SERVICE PROCEDURE

**G-07503
March 2007**

**SUBJECT: SAFETY RECALL (U.S., EXPORT)
SIDE EMERGENCY DOOR HOLDBACK on certain CE,
RE and FE School and Commercial Buses built
3/12/2004 thru 11/29/2006**

Figure 2

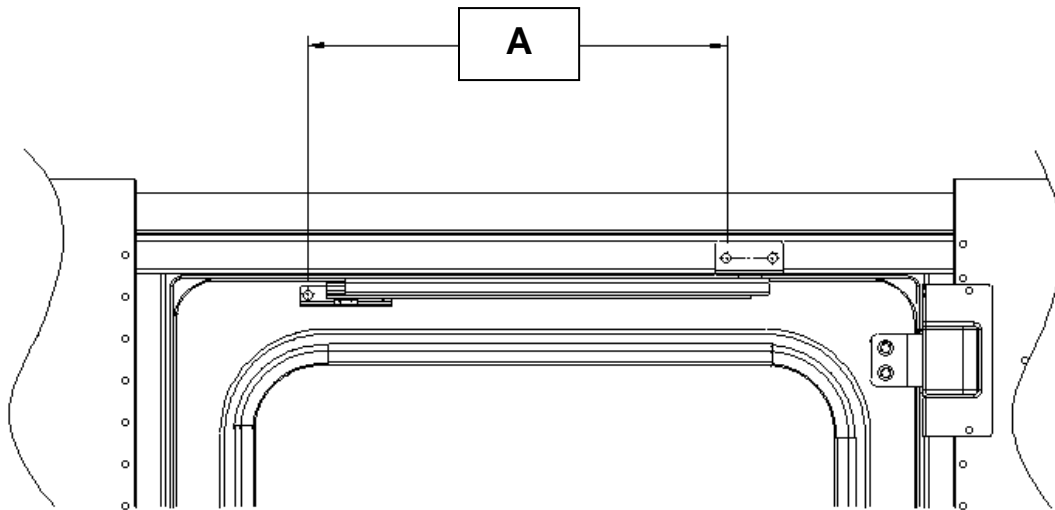
2. Measure dimension **A** on the hold back mechanism bolt pattern indicated below:

- a. If dimension **A** is **13"** (330mm) or **greater**, then no further action is necessary, re-install header bumper.
- b. If dimension **A** is **less** than **13"** (330mm), continue on to step 3.

Figure 3

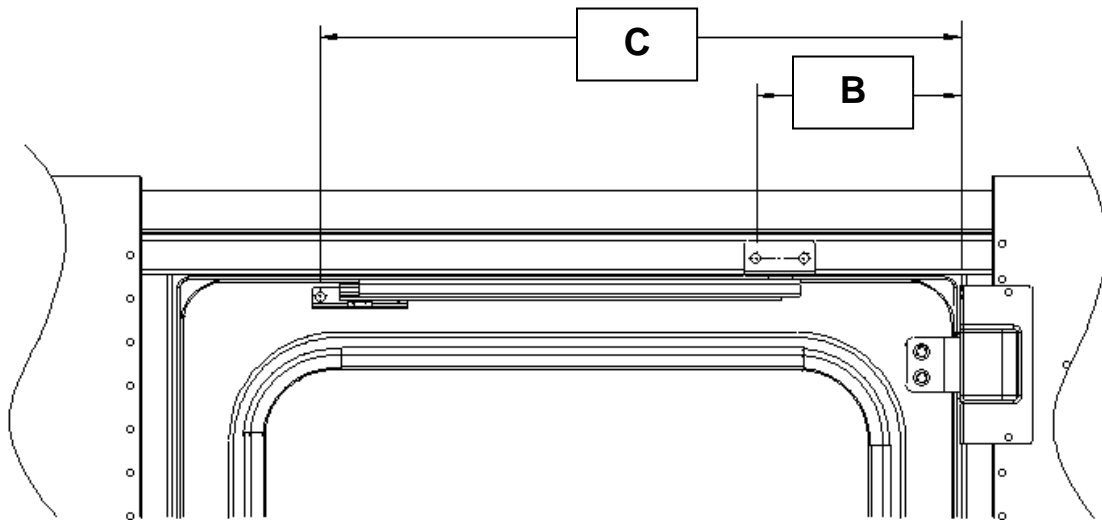
3. If dimension **A** is less than **13" (330mm)**:
 - a. Remove bolts from holdback mechanism.
 - b. Measure location for new hole using Nominal dimension from Table 1.
Measure from door frame surface, not hinge surface.
 - c. Drill hole with **#5** drill bit.
 - d. Use holdback bracket as a template to mark and drill second holes.
 - e. Reinstall holdback mechanism using existing hardware.

<u>Dimension</u>	<u>Nominal</u>
B	6.5" (165mm)
C	20.375" (517mm)
